**Gerald R. Ford International Airport**

**Taxilane L Construction**

**PROJECT NUMBER C-416**

**ADDENDUM #1**

**CONSTRUCTION  
SAFETY AND  
PHASING PLAN -  
WORK AREA B**

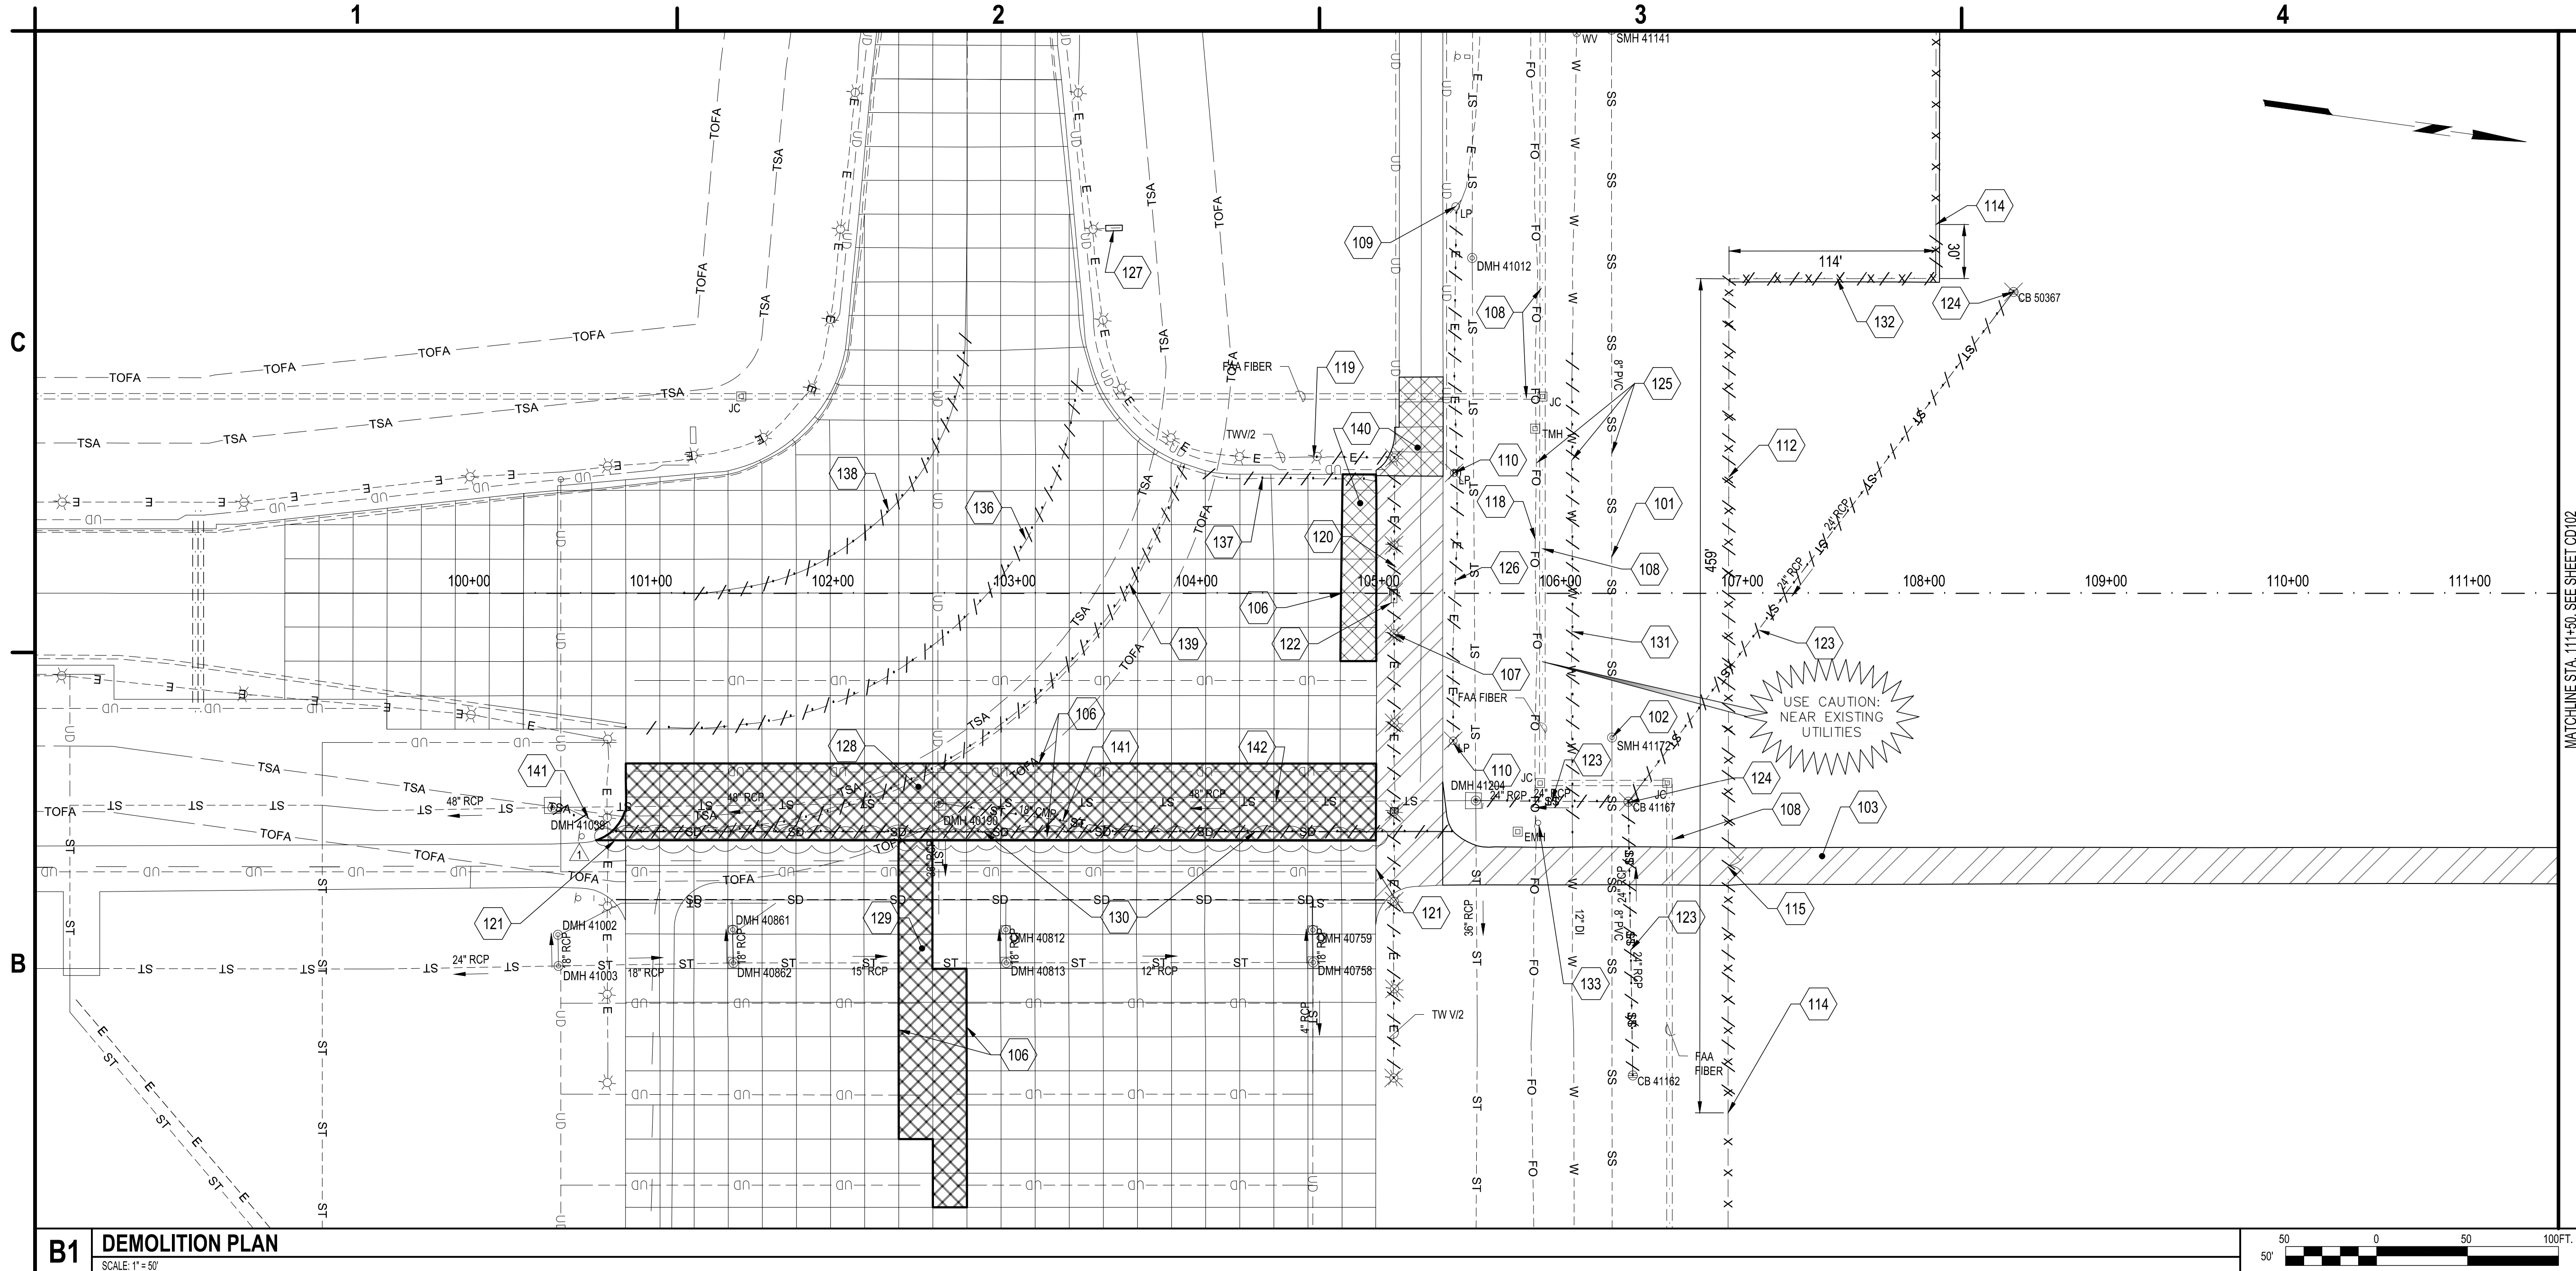
Q: Will a batch plant site be allowed? It's about 75 feet in height

A: Yes, please see sheet GC100 of the plans.

**B1 DRAINAGE AND UTILITIES PLAN**  
SCALE: 1" = 50'

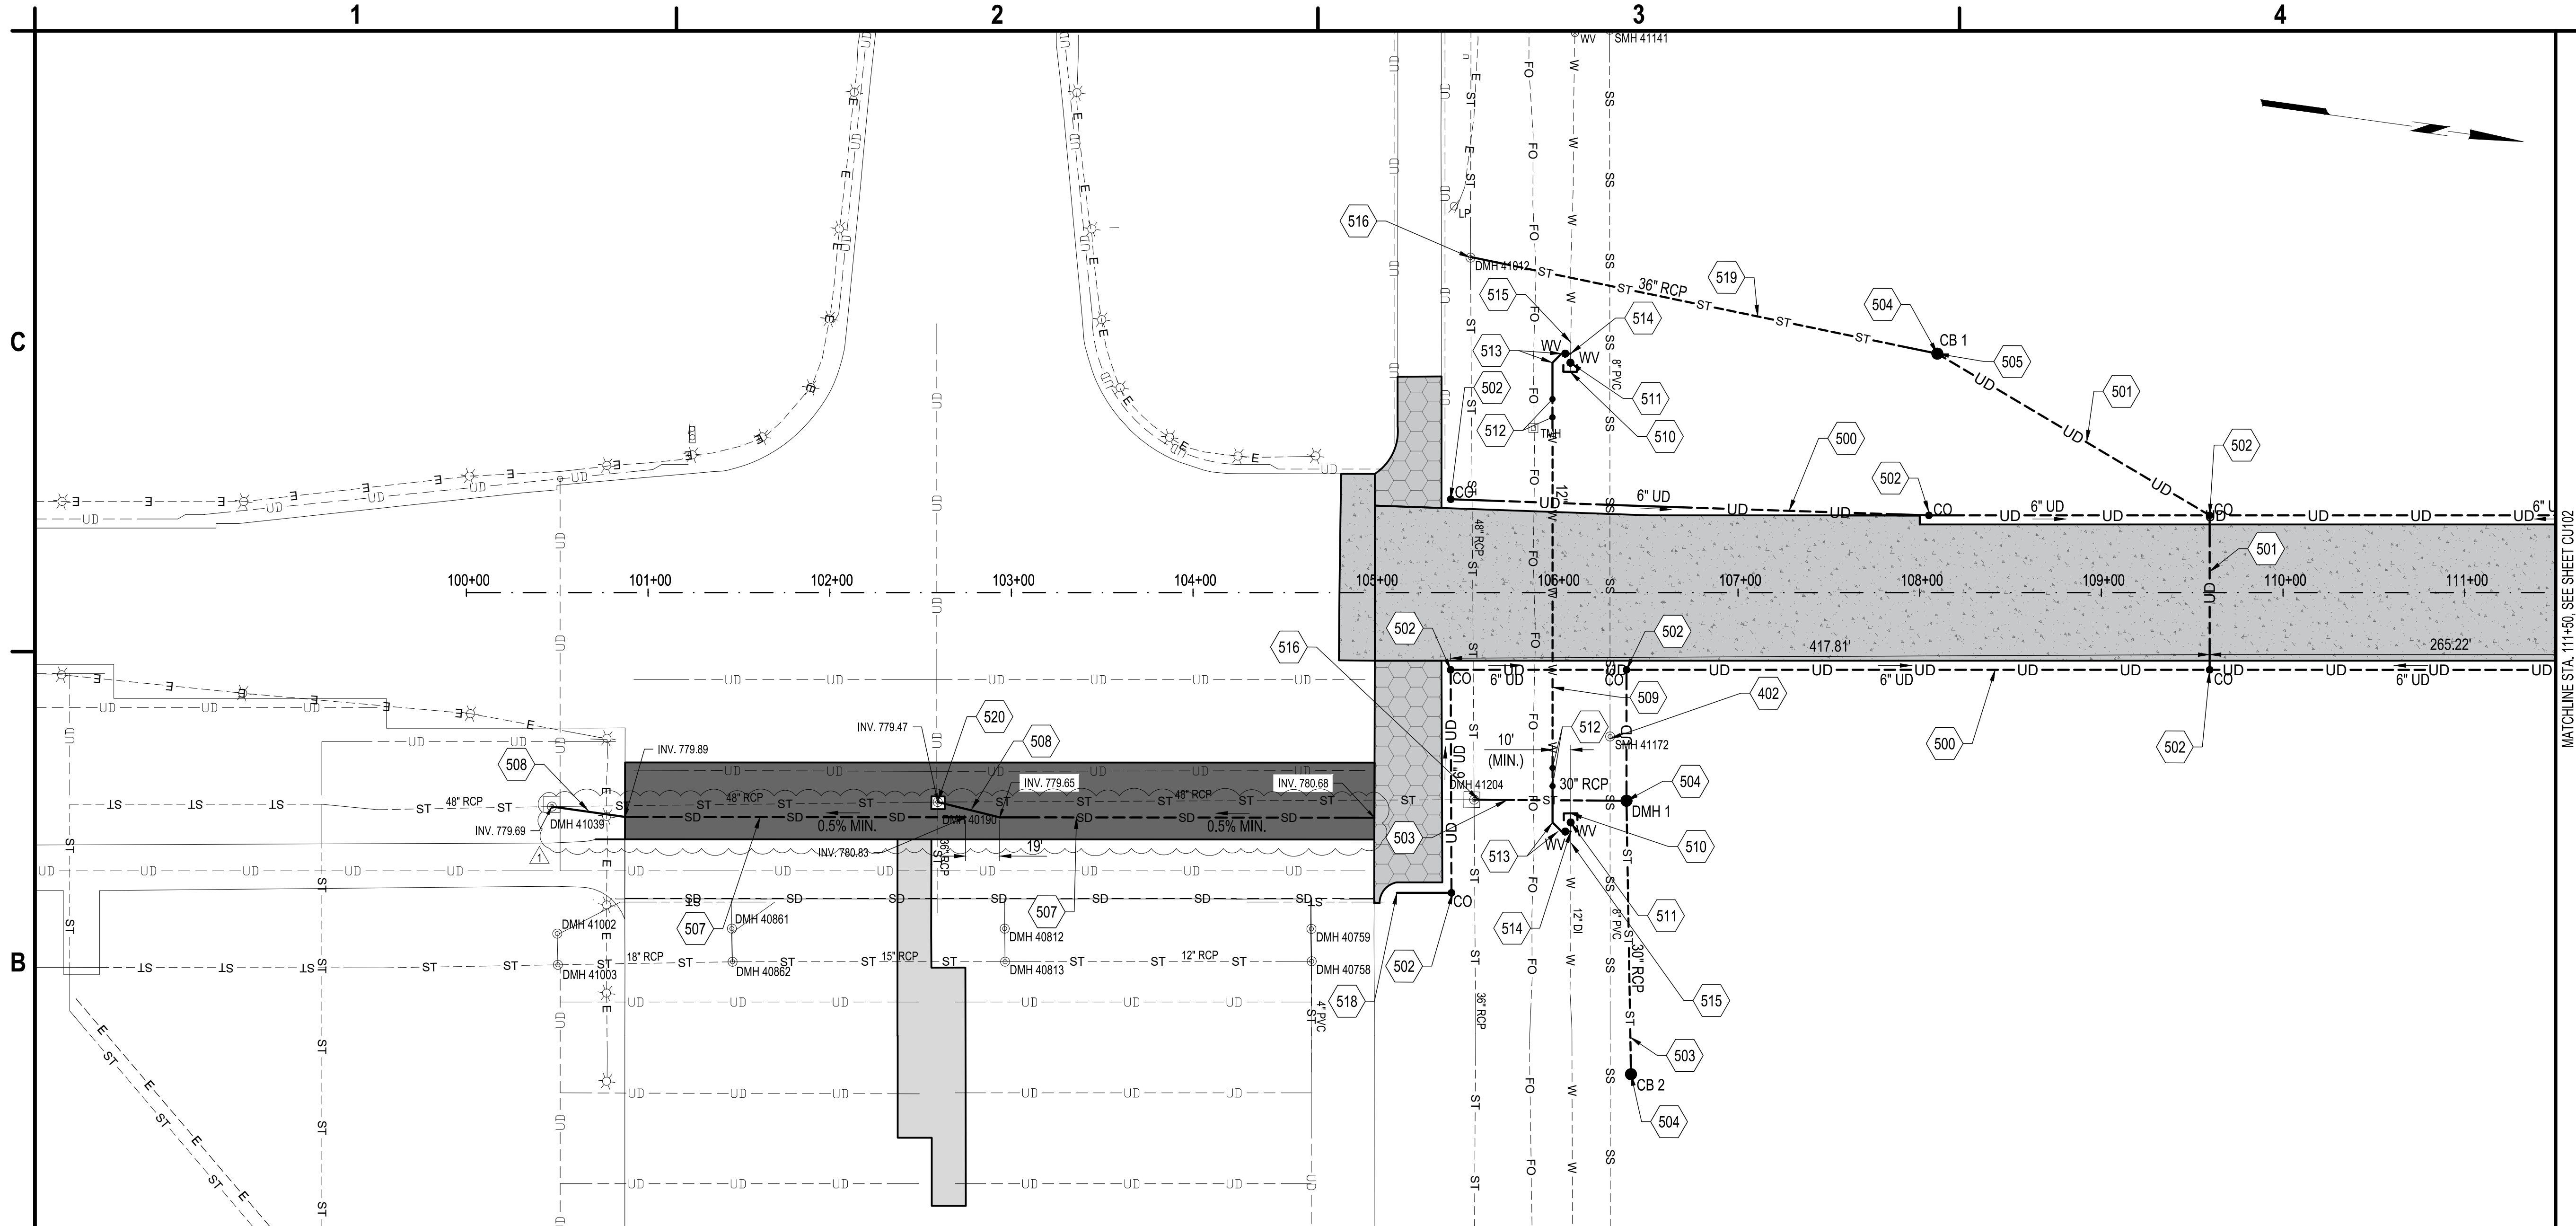
10. **REPLACE** Drawing CU502 with **REVISED** CU502 sheet provided with this addendum as a separate document. Revisions are denoted with a cloud referenced to Revision 1 dated AUGUST 29, 2025.

11. **REPLACE** Drawing CU503 with **REVISED** CU503 sheet provided with this addendum as a separate document. Detail C3 has been moved from CU502 to CU503 as denoted with a cloud referenced to Revision 1 dated AUGUST 29, 2025.

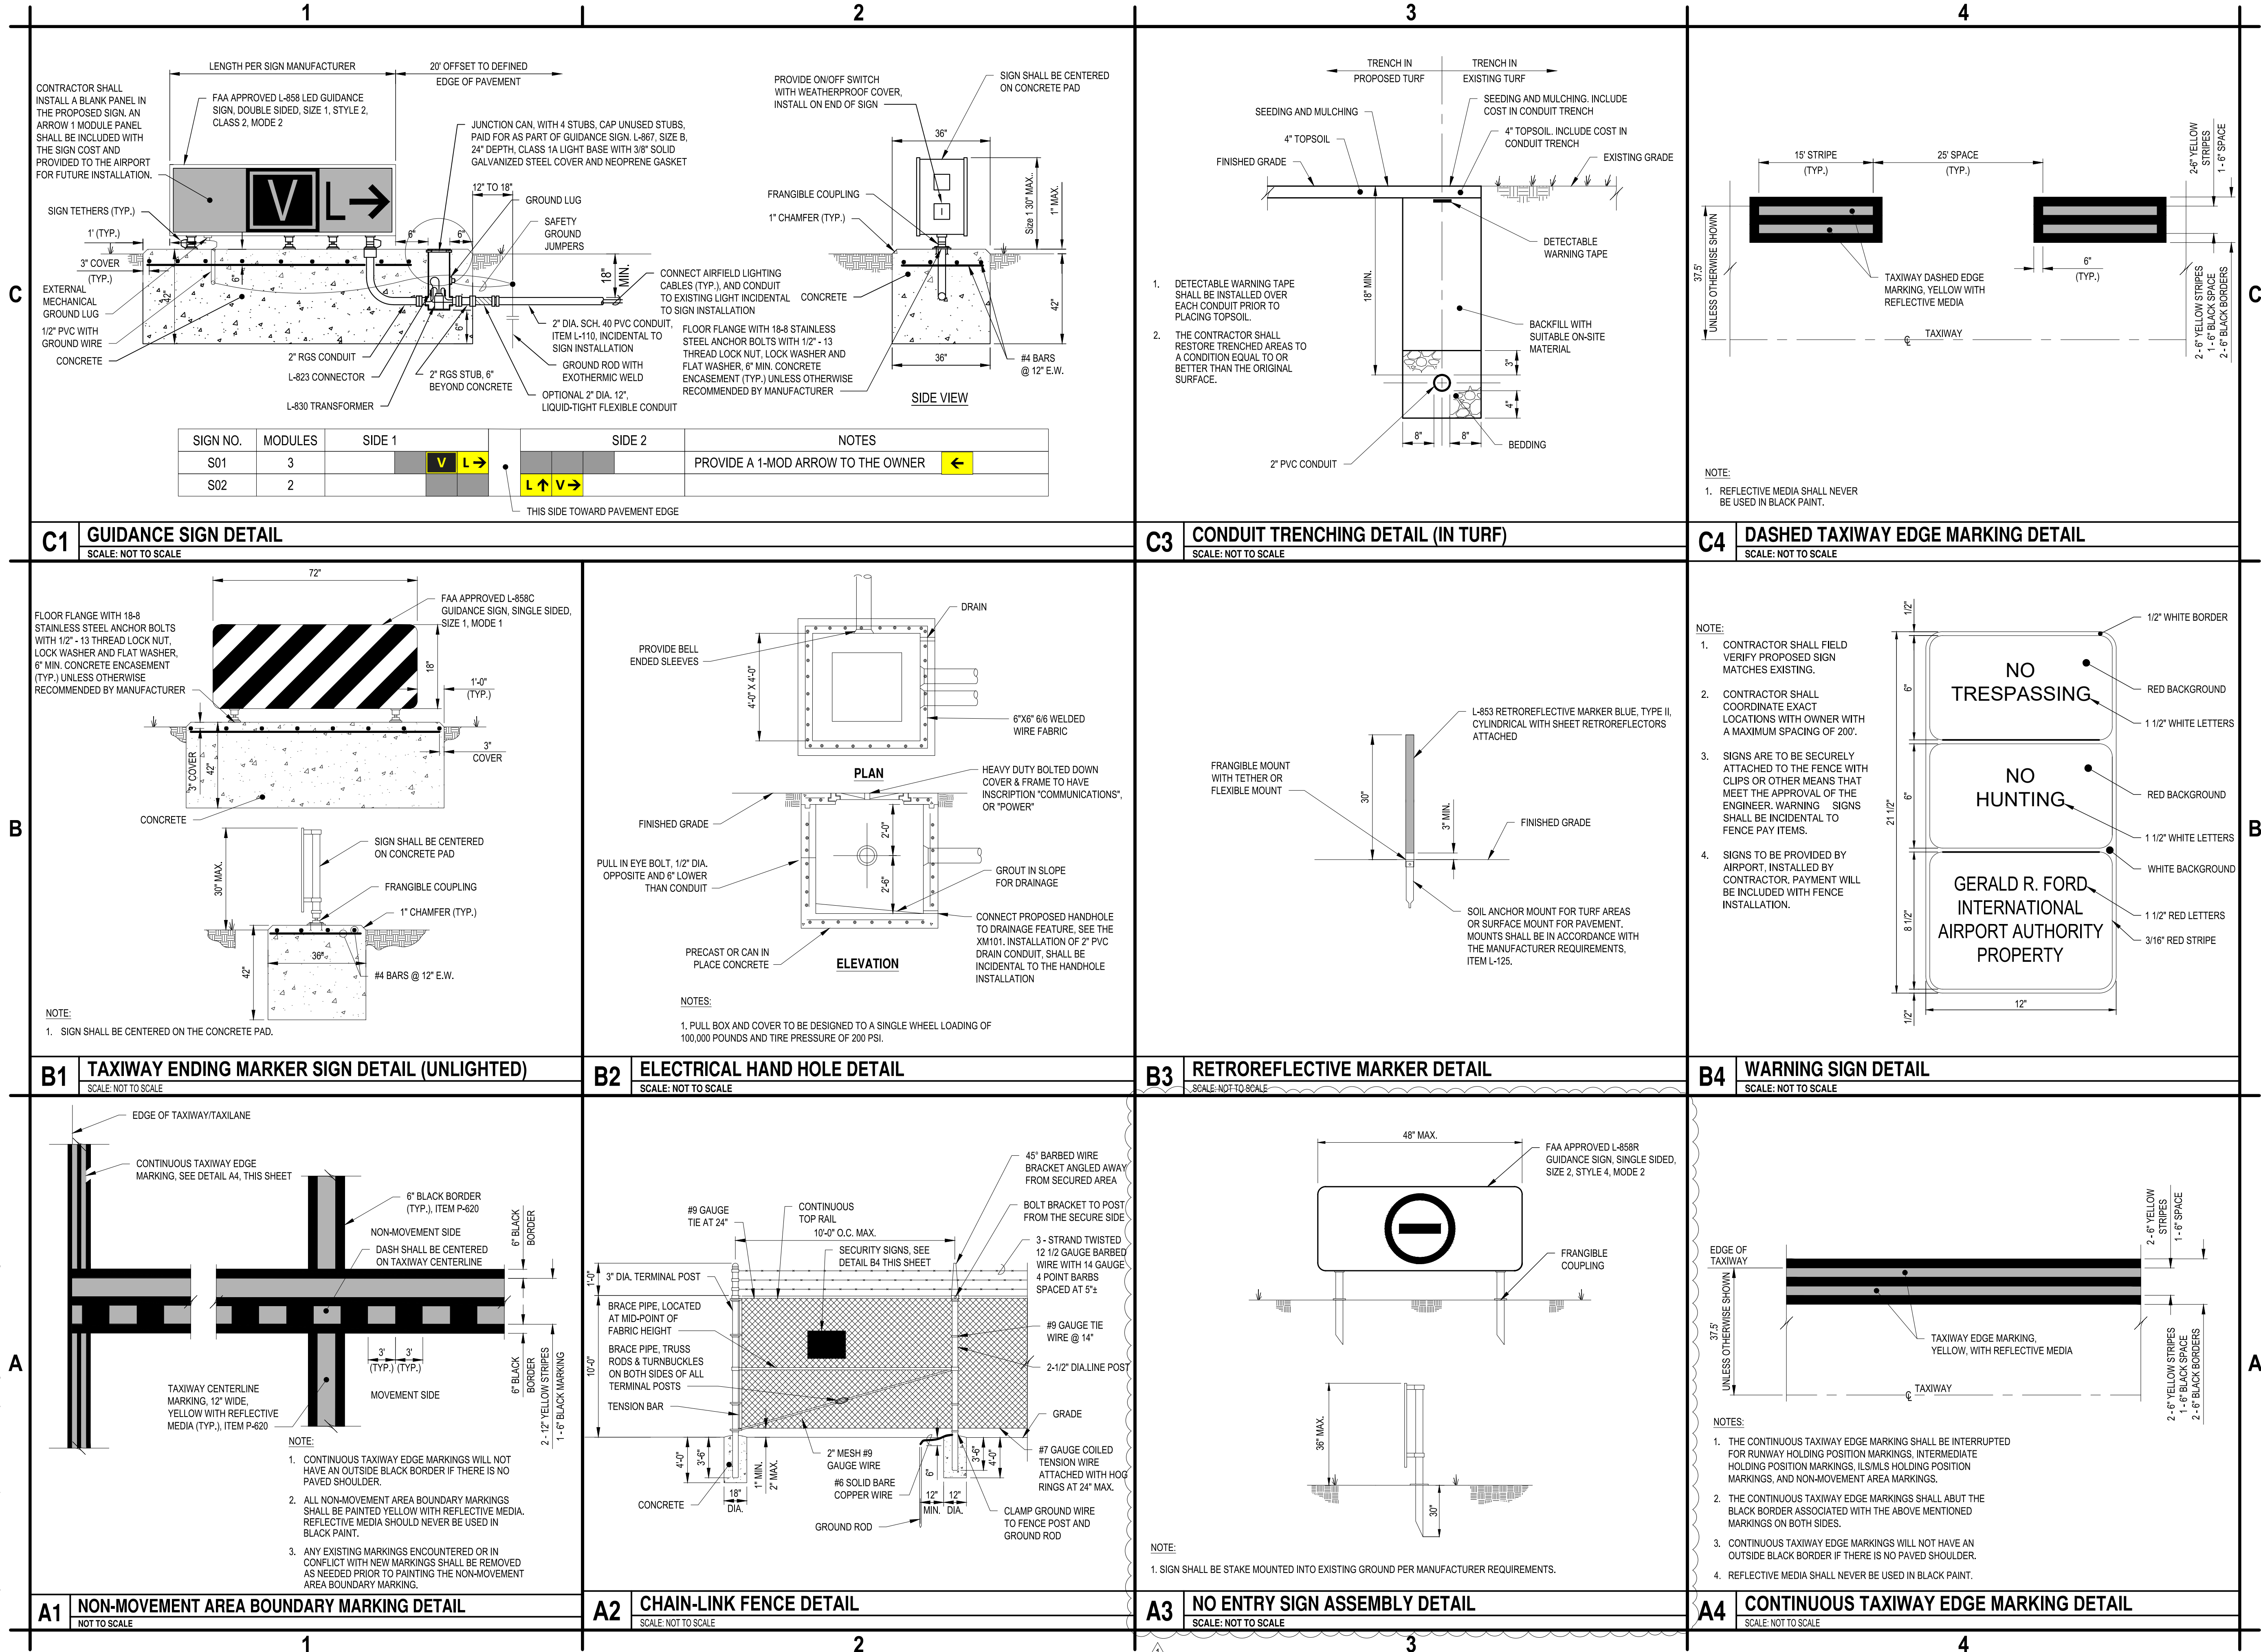
- Q: XM501 – A3 notes the No Entry Sign as manufactured by Lumacurve. Is this item sole-sourced, or will other manufacturers be considered?
- A: It is not a sole-sourced item and other manufacturers will be considered as long as they meet the FAA requirements.
